THE VILLAS AT CLAREMONT RANCH

PUD DEVELOPMENT PLAN & PRELIMINARY PLAN

DATE: BY: DESCRIPTION
9/17/21 JS County Comments

PUD MODIFICATION TABLE

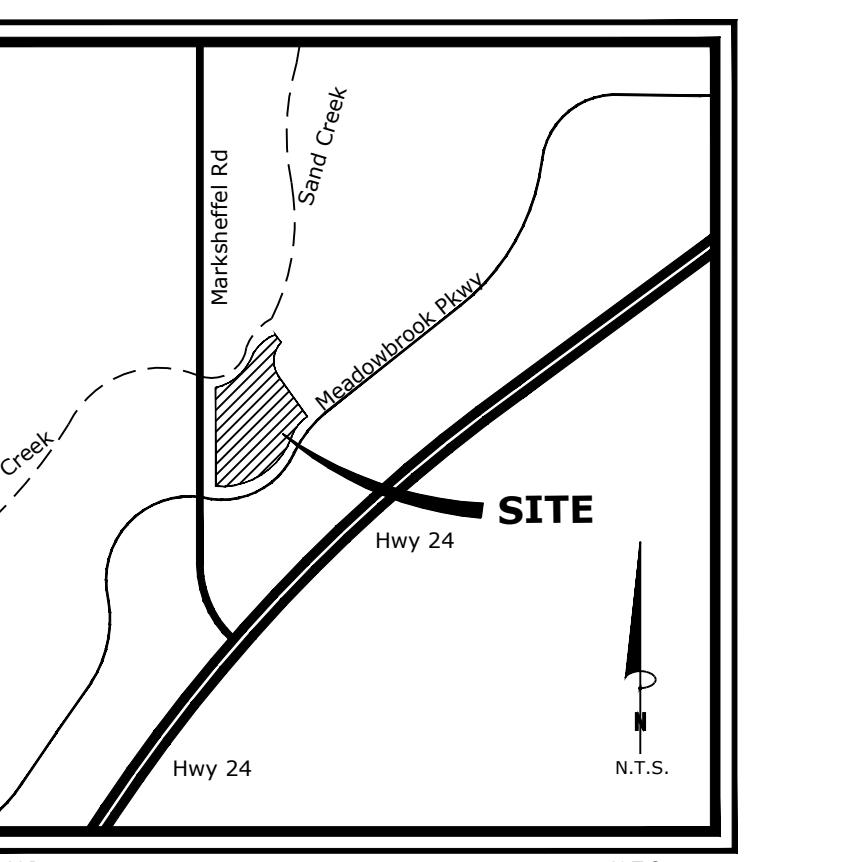
4 and 5 are missing?

LANDSCAPE CODE REQUIREMENTS

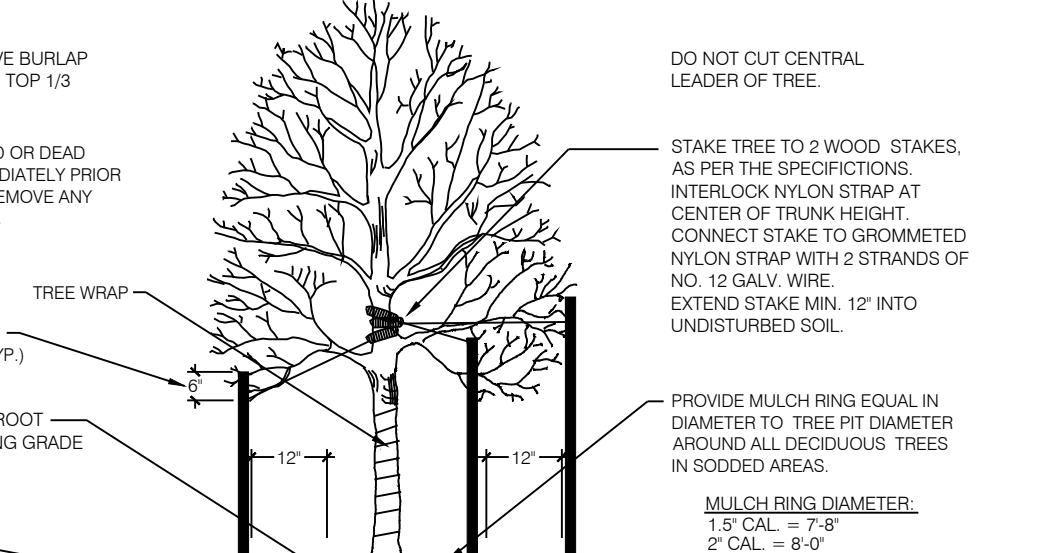
Need to include reference to alternate landscape request. Make reference here and include justification on landscape plan page

Alternative Landscape Plan is requested per setback requirements on Marksheffel Road (LDC Section 6.2.2) due to utility easement constraints

Final Landscape Plan

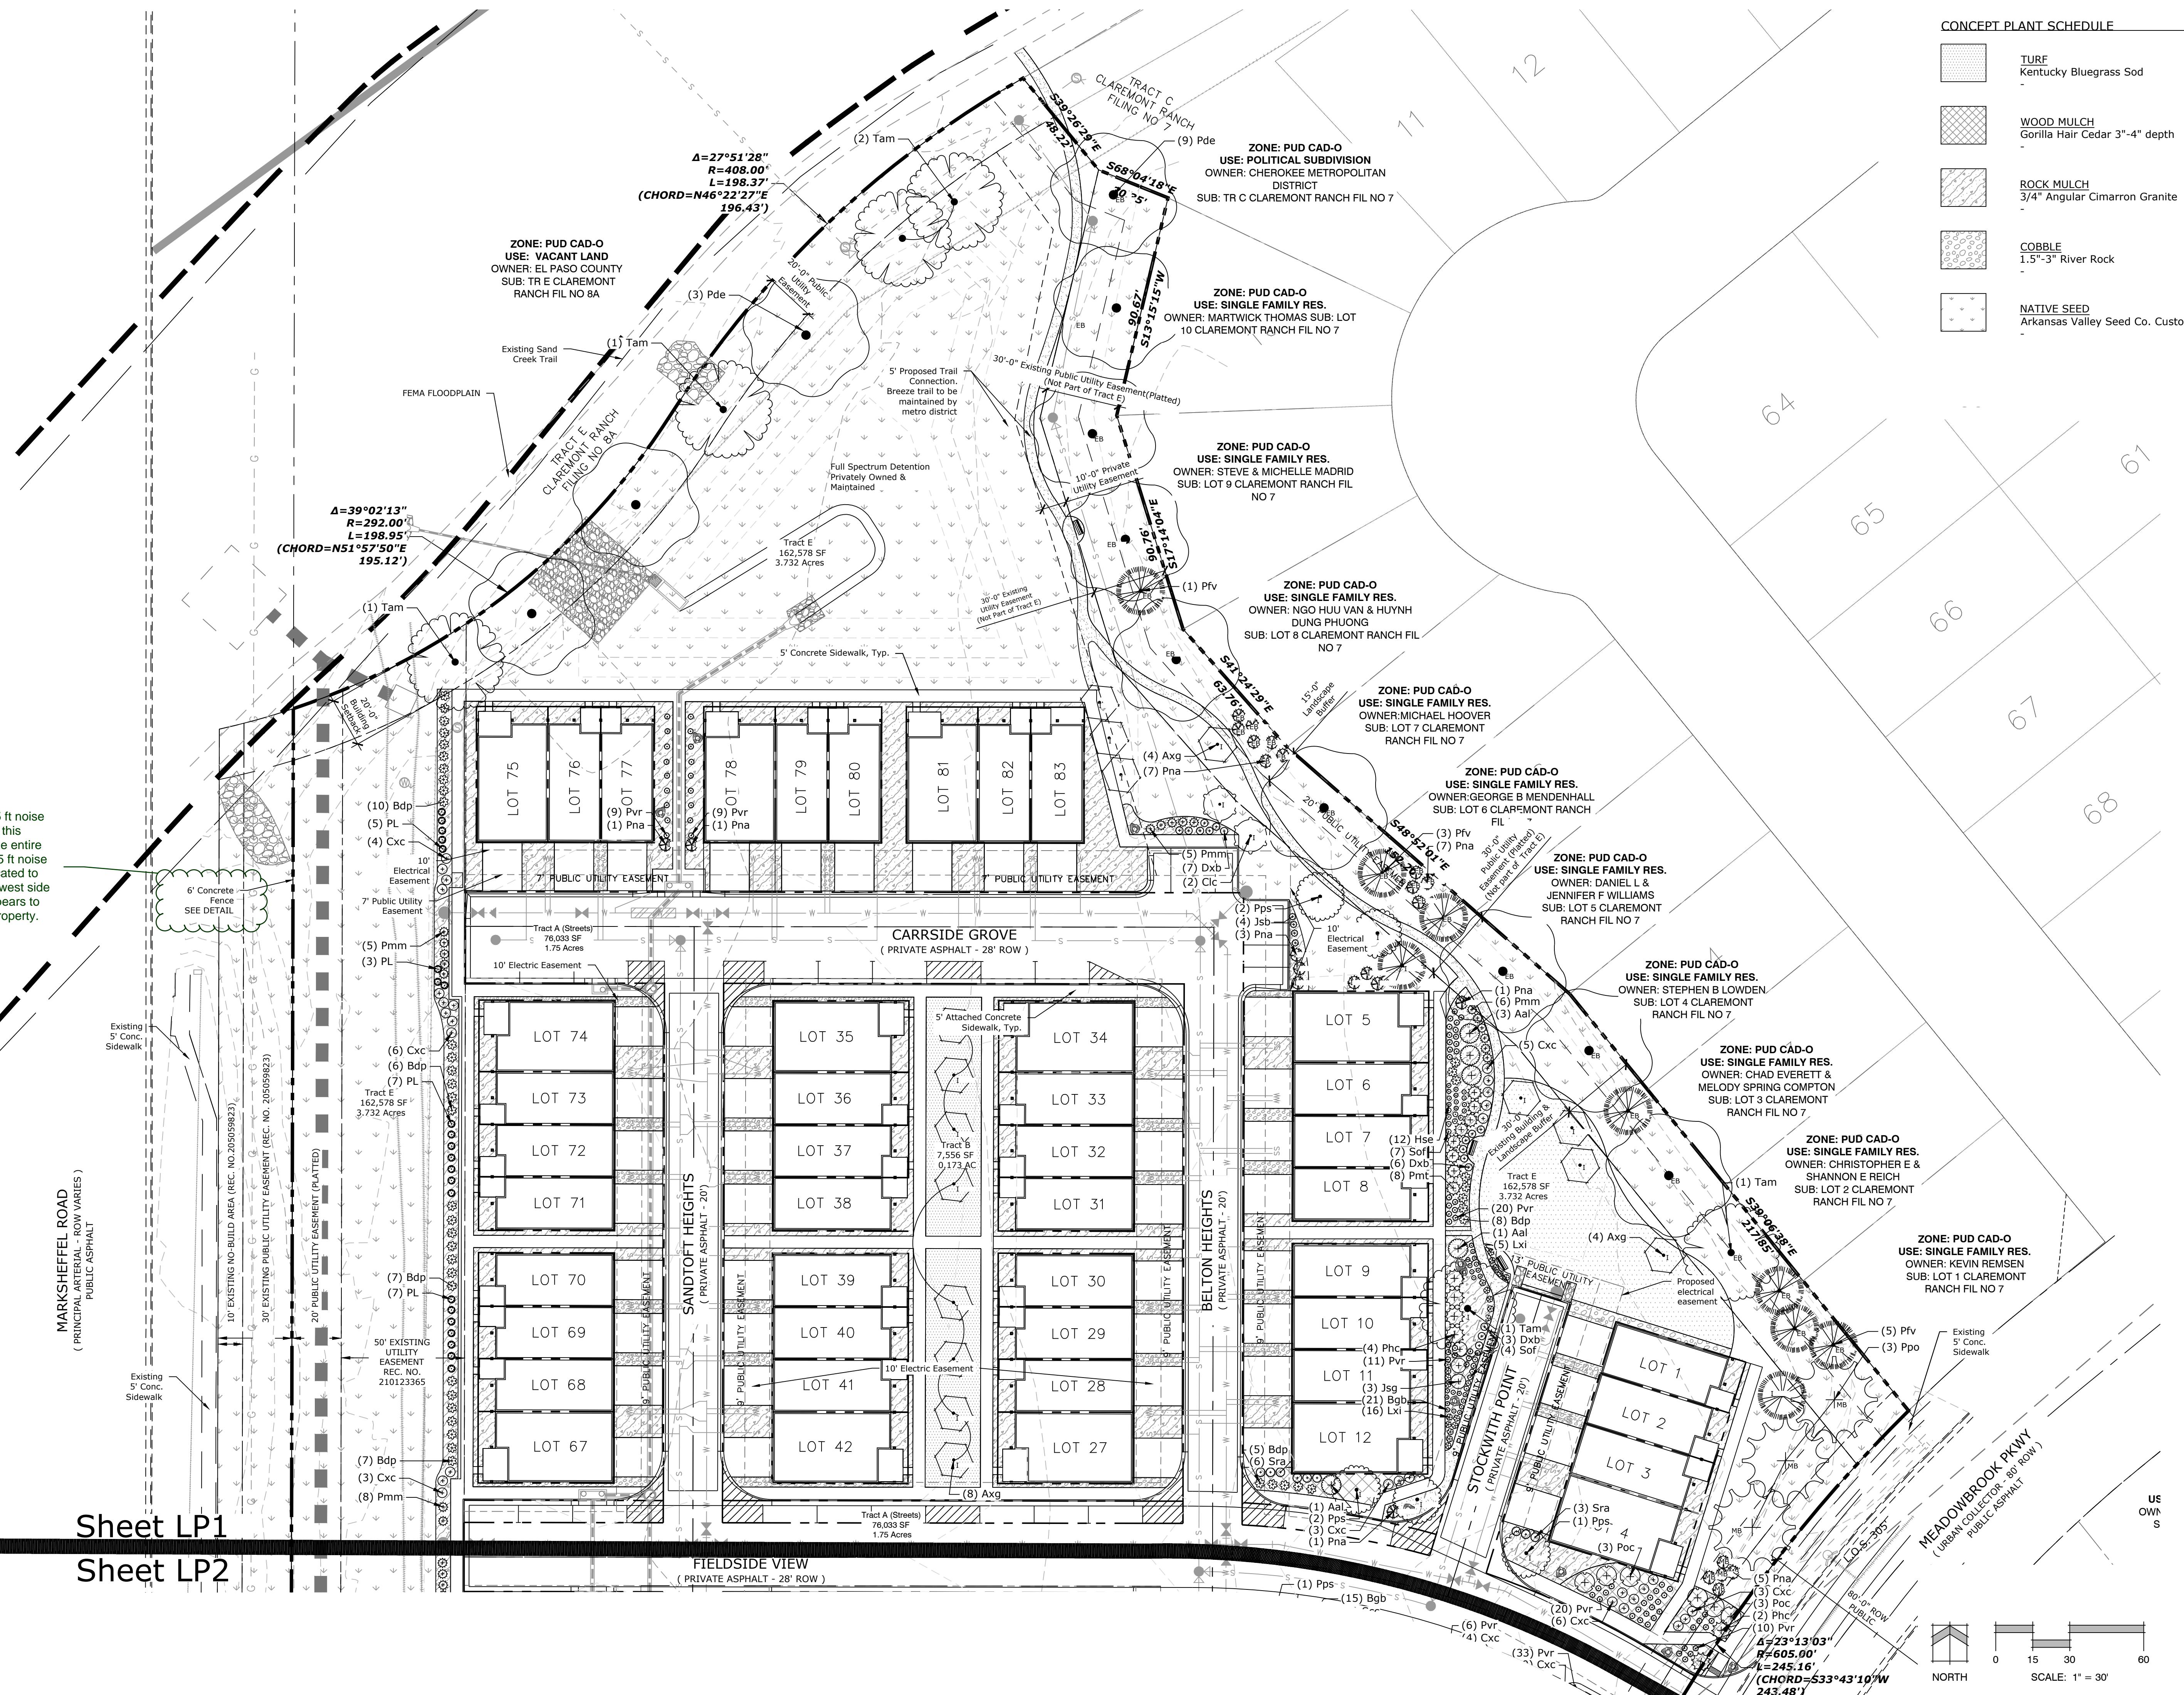
Is this the 5 ft noise wall? Does this surround the entire property? 5 ft noise wall is indicated to only be on west side but this appears to surround property.

Final Landscape Plan

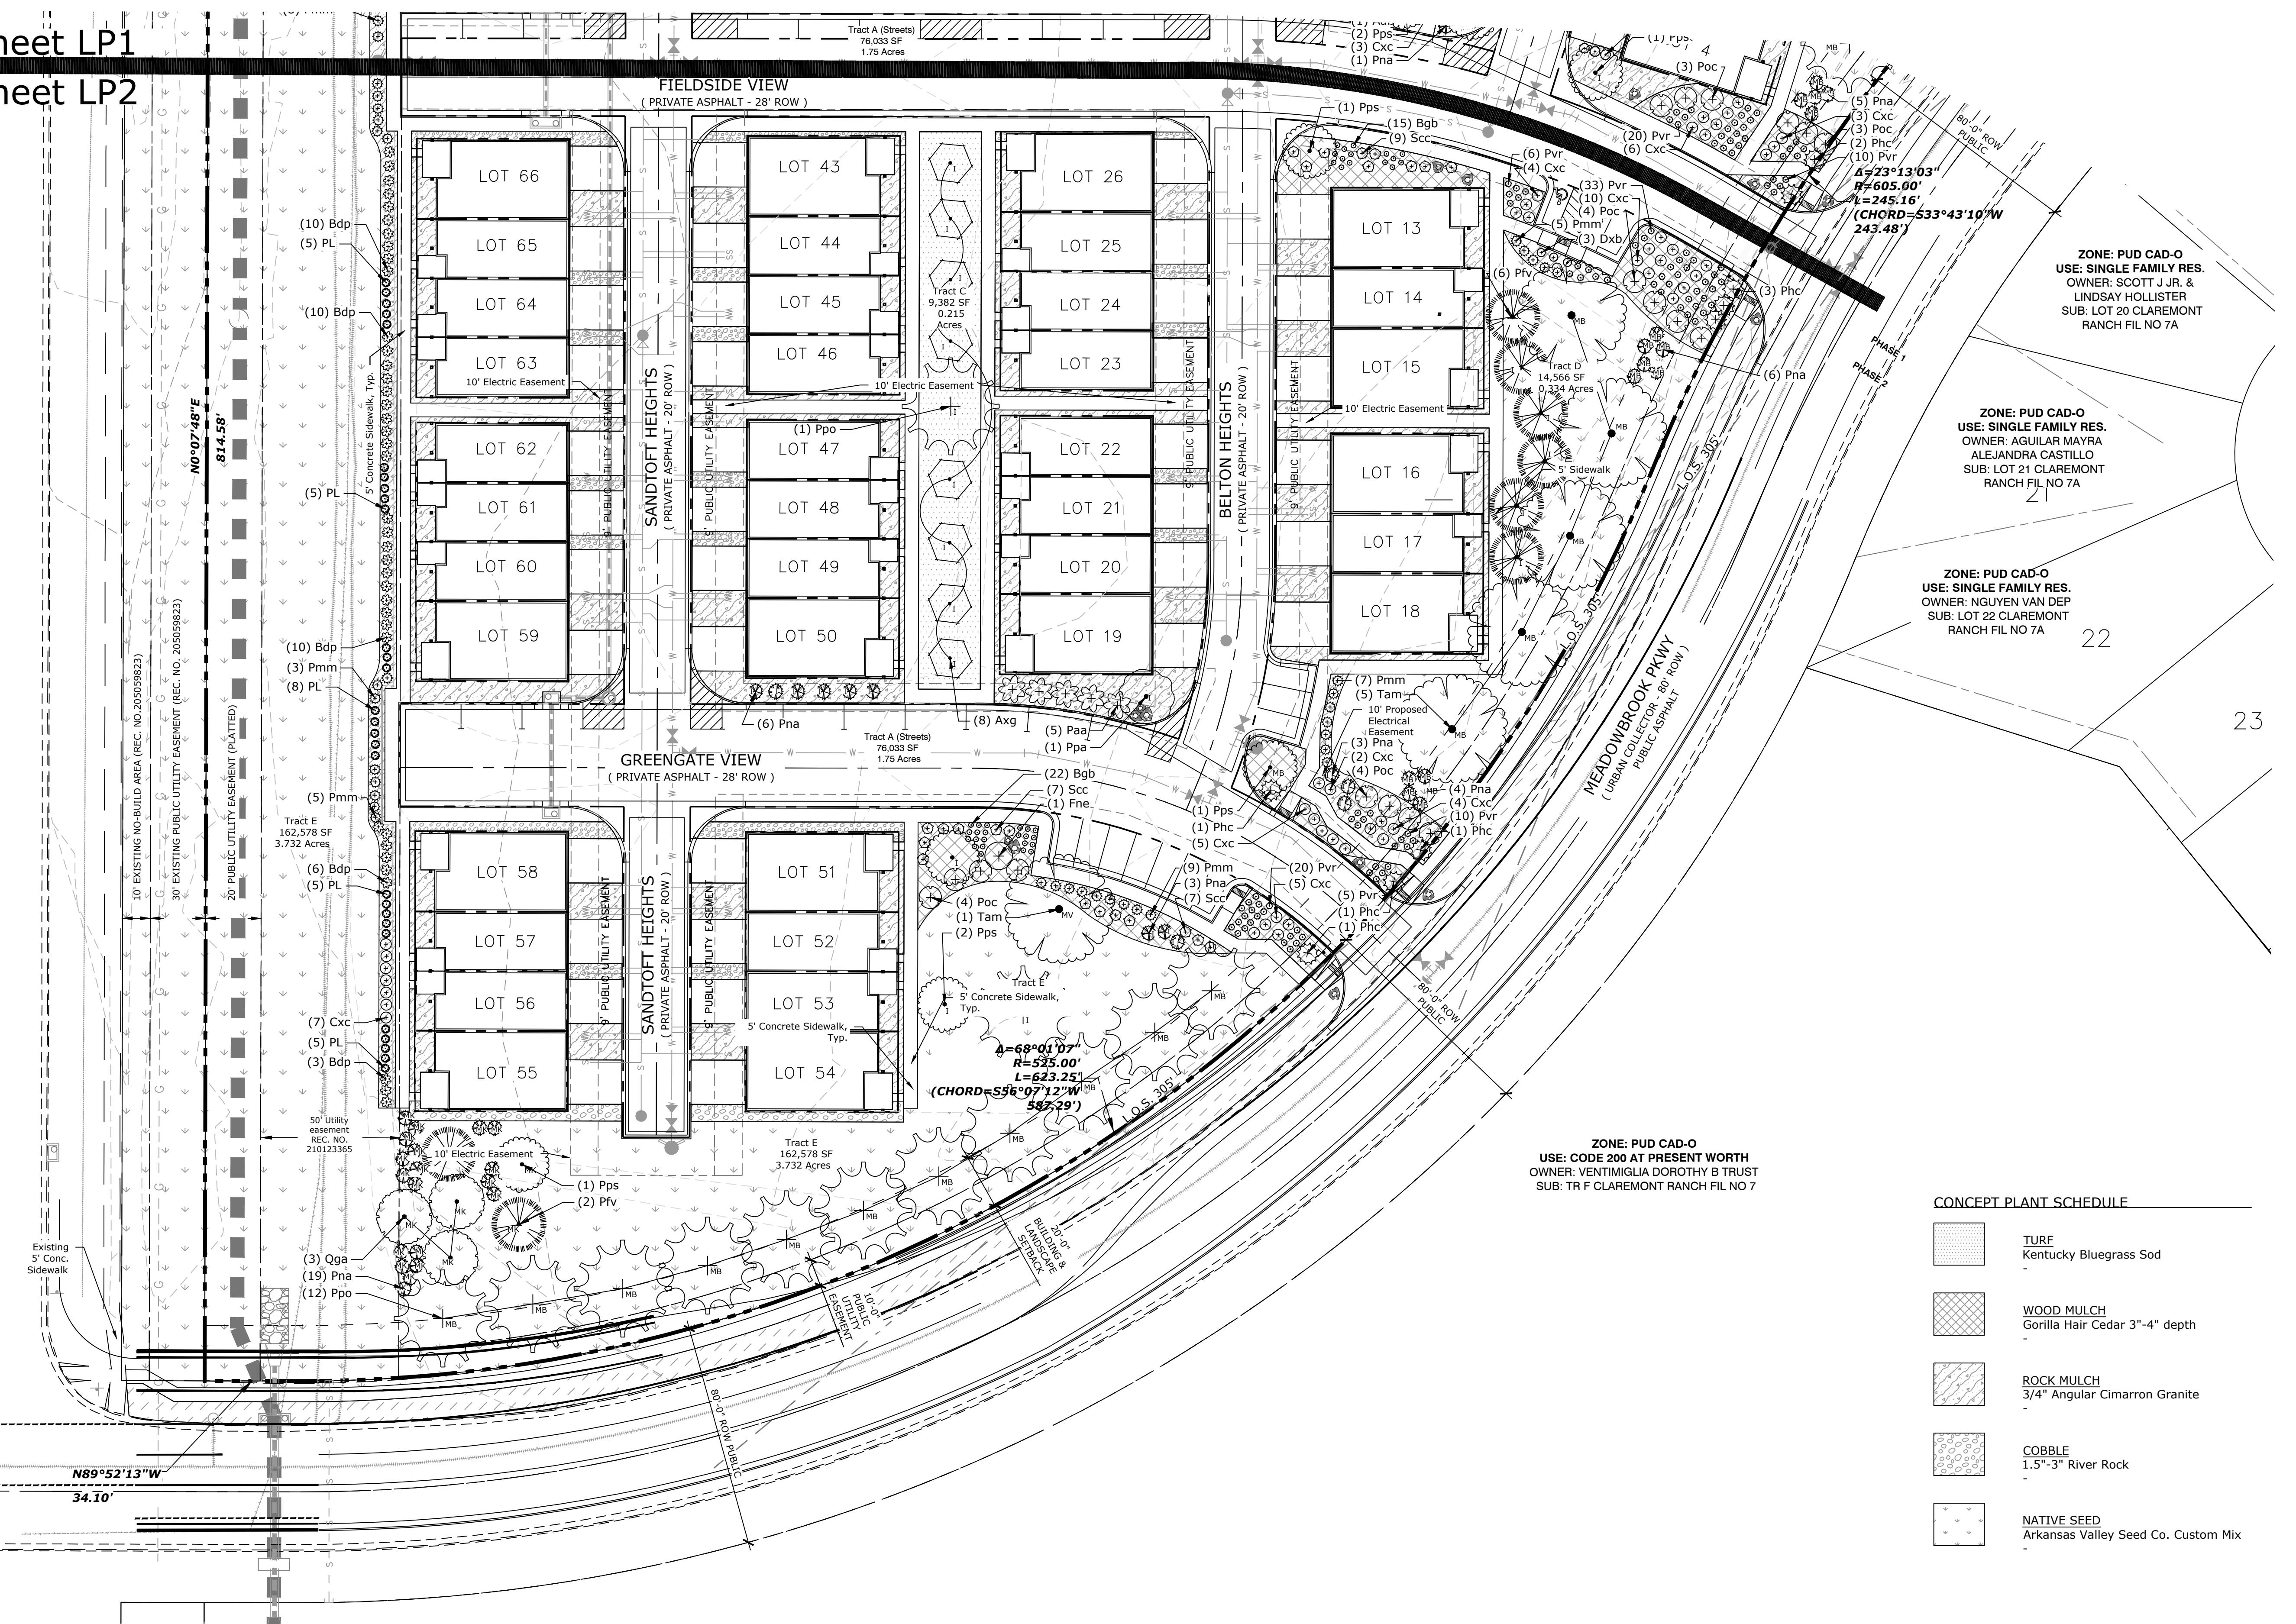
No reference to
fencing or noise
wall on this page.
Duplicate labels if
necessary.
